OIL - OIL REPLACE THE CLIPPING BRACKET ON THE AIR COOLED OIL COOLER AT CP0533 -
CATEGORY CODE 3 - MOD.ENG-79-0005

V2500-ENG-79-0005

Location of clipping bracket on the ACOC
Fig.1

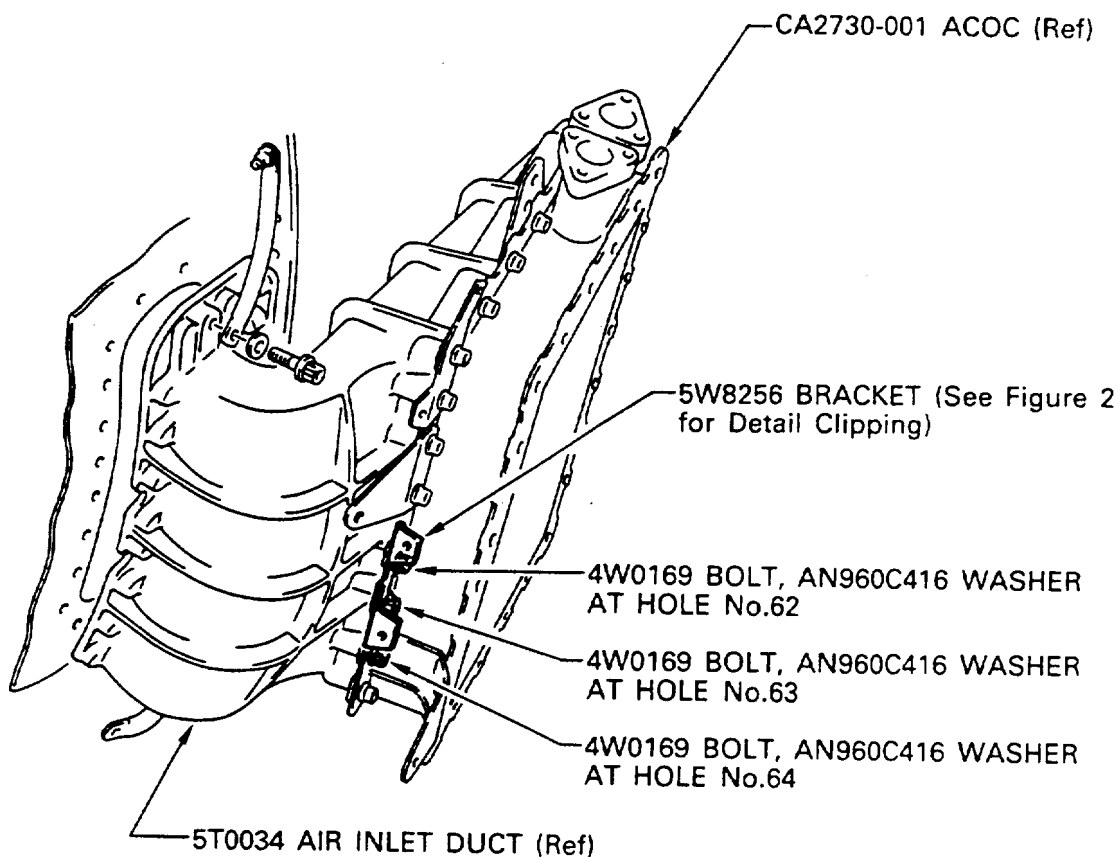
(3) Remove PN 4W0169, Bolts (3 off) and PN AN960C416, Washers (3 off) which attach PN CA2730-001, ACOC (Ref.) to PN 5T0034, Air Inlet Duct (Ref.) at the Hole No.'s 62 63 and 64.	Refer to Figure 1.

(7) Install New PN 5W0091, Bracket to PN CA2730-001, ACOC (Ref.) at the Hole No.'s 63 and 64.	Refer to Figure 3.
(8) Install PN AN960C416, Washers (3 off) and PN 4W0169, Bolts (3 off) to PN CA2730-001, ACOC (Ref.) at the Hole No.'s 62, 63 and 64.	Refer to Figure 1.

- (10) Tighten PN 4W0169, Bolts (3 off) which attach PN CA2730-001, ACOC (Ref.) to PN 5T0034, Air Inlet Duct (Ref.) to a torque of 85 - 105 lbfin (10,00 - 12,00 Nm),

View on clipping bracket on the ACOC at CP0533 - Before alteration
Fig.2

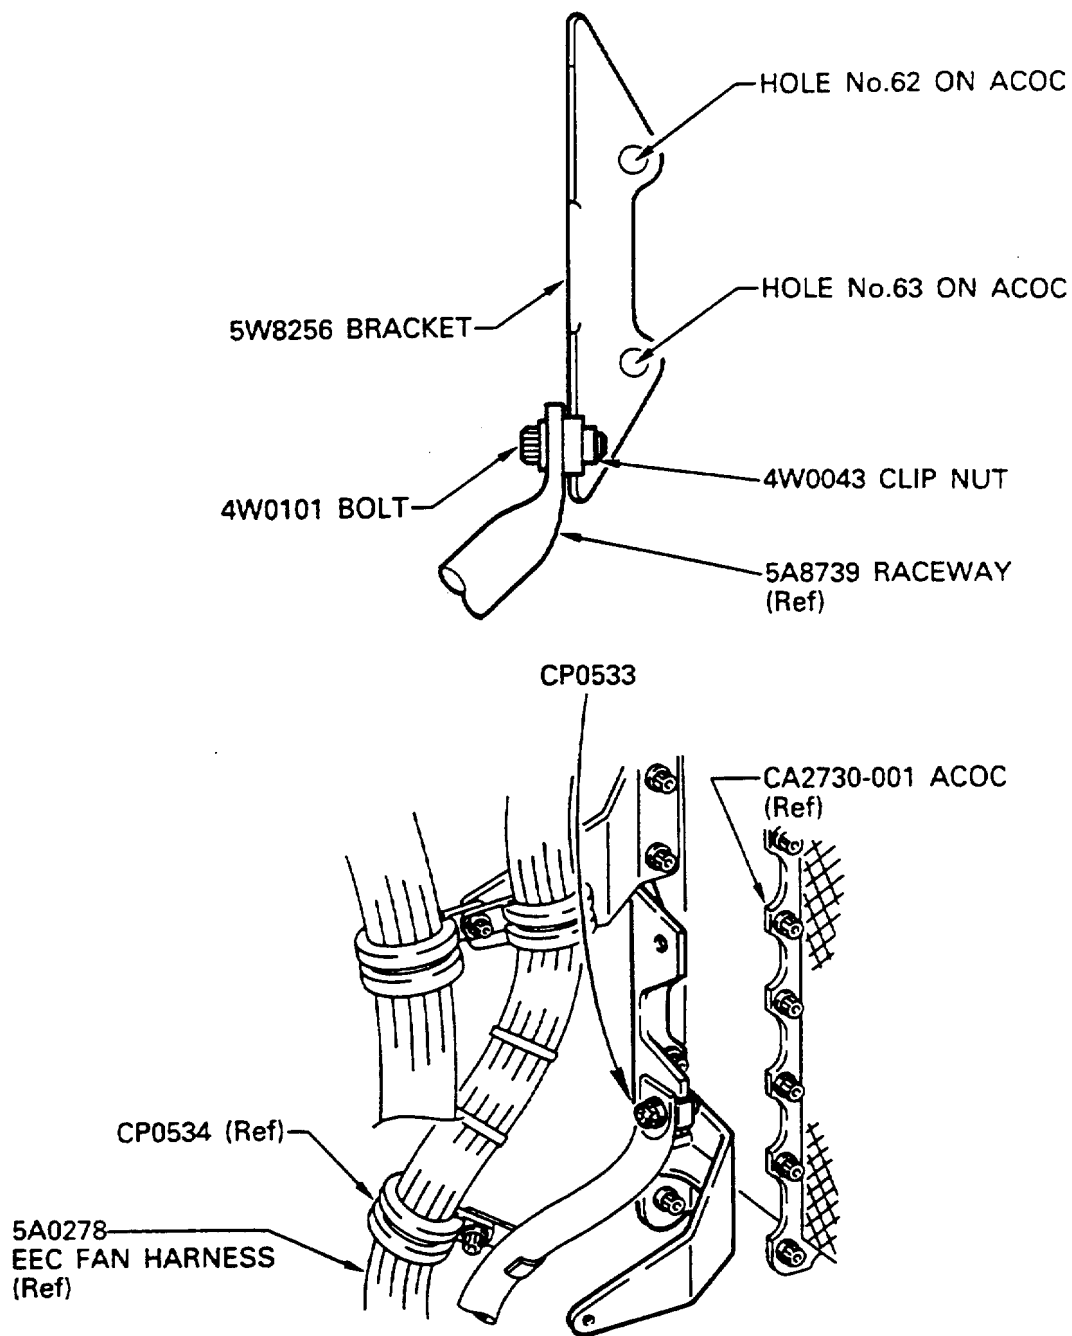
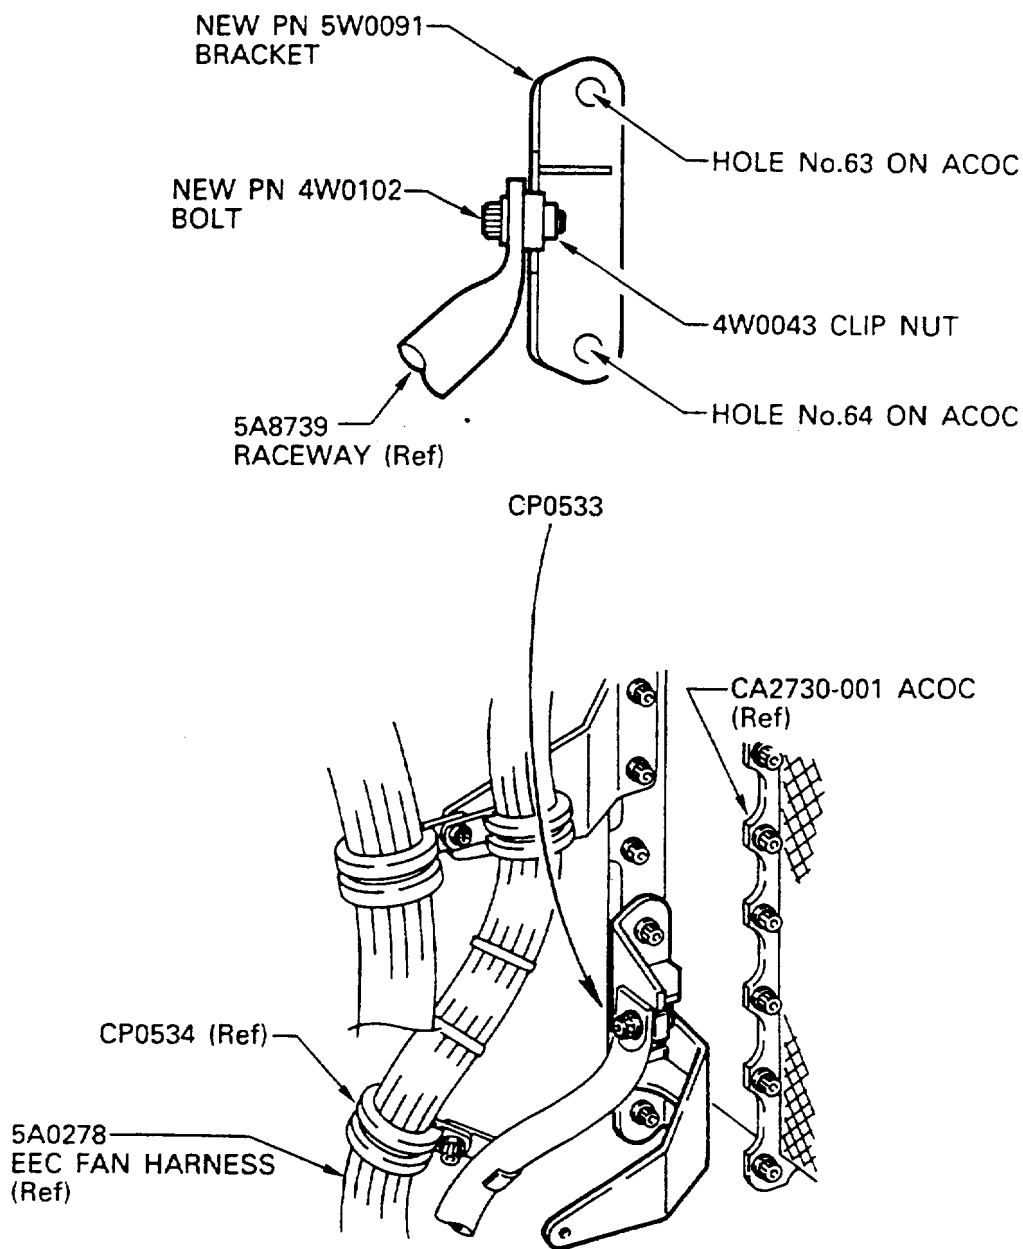
- (a) A gusset is welded to new Clipping Bracket, of which stock thickness is also changed from 0.047in. (1,2 mm) to 0.063in. (1,6 mm) to clear the resonance.
- (b) The new Clipping Bracket is relocated downward by one hole of the ACOC attaching bolt holes.
- (c) At CP0533, the Clip Bolt is changed to use a new longer Bolt to accomodate with the new thickner Bracket.
- (d) Figure/Item Number of new Bracket is changed from 79-21-42 01-086 to 79-21-42 01-070.

Procedure	Supplementary Information
(1) Find the location of PN 5W8256, Bracket on PN CA2730-001, ACOC (Ref.).	Refer to Figure 1.
(2) Remove PN 4W0101, Bolt which attaches PN 5A8739, Raceway (Ref.) to PN 5W8256, Bracket at CP0533.	Refer to Figure 2.

(4) Remove PN 5W8256, Bracket from PN CA2730-001, ACOC (Ref.).	Refer to Figure 2.
(5) Remove PN 4W0043, Nut from PN 5W8256, Bracket.	Refer to Figure 2.
(6) Install PN 4W0043, Nut to New PN 5W0091, Bracket.	Refer to Figure 3.

- (9) At CP0533, install New PN 4W0102, Bolt which attaches PN 5A8739, Raceway (Ref.) to New PN 5W0091, Bracket.

- (11) Tighten New PN 4W0102, Bolt to a torque of 36 - 45 lbfin (4,00 - 5,00 Nm) at CP0533.
